Access Compliance Report

Public Rights-of-Way

Intersection ID: 47968	Main Street: MESA_VERDE_RD	Cross Street: KYRENE_RD	Location: SE
ADA ID: A367AEB4DD76	Ramp Type: PerpDiag	Initial Pass/Fail: Fail	Overall Compliance: No
Severity Score: 21.25			
Codes/Mitigation Info/Possible Solution		Field Measurements/Component Compliance

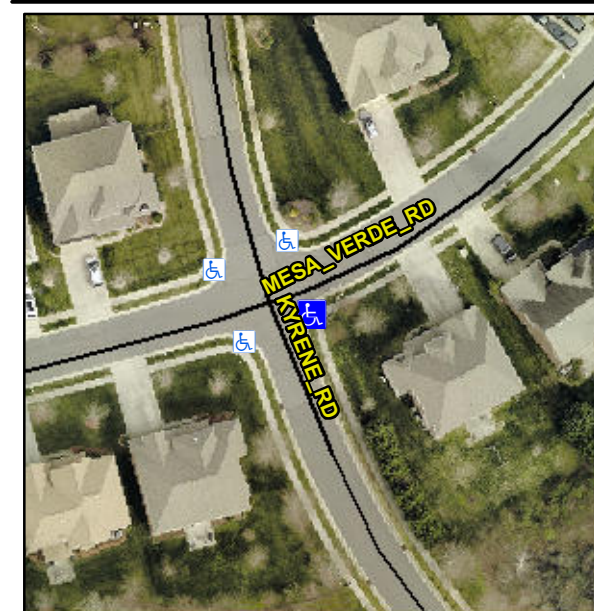
Not Found, R304.5.1, R304.2.2

Compliance	Description	Data	Compliance	Description	Data
N/A	Ramp Length (in)	48.0	No	Ramp Slope (%)	10.2
No	Ramp Width (in)	45.5	Yes	Ramp XSlope (%)	1.5
N/A	Flare Type LT	N/A	N/A	Flare Type RT	N/A
N/A	Flare Slope LT (%)	N/A	N/A	Flare Slope RT (%)	N/A
N/A	Flare Traversable LT?	N/A	N/A	Flare Traversable RT?	N/A
N/A	Landing Length (in)	N/A	N/A	DWS Provided?	N/A
N/A	Landing Width (in)	N/A	N/A	DWS Contrast?	N/A
N/A	Landing Slope (%)	N/A	N/A	DWS Length (in)	N/A
N/A	Landing X Slope (%)	N/A	N/A	DWS Full Width?	N/A
N/A	Landing Curb? (Y/N)	N/A	N/A	DWS Offset (in)	N/A
N/A	Shared Landing?	N/A			
N/A	Gutter Ponding?	N/A	N/A	Gutter Slope (%)	N/A
N/A	Gutter Lip Ht (in)	N/A	N/A	Gutter X Slope (%)	N/A
N/A	Painted X Walk1?	No	N/A	Painted X Walk2?	No
	X Walk 1 Direction	To N		X Walk 2 Direction	To W
N/A	X Walk 1 Width (in)	N/A	N/A	X Walk 2 Width (in)	N/A
	X Walk 1 Slope (%)	4.6		X Walk 2 Slope (%)	1.5
	X Walk 1 X Slope (%)	2.6		X Walk 2 X Slope (%)	5.0

Remove & Replace Curb Ramp With Two New Directional Ramps or Equivalent.
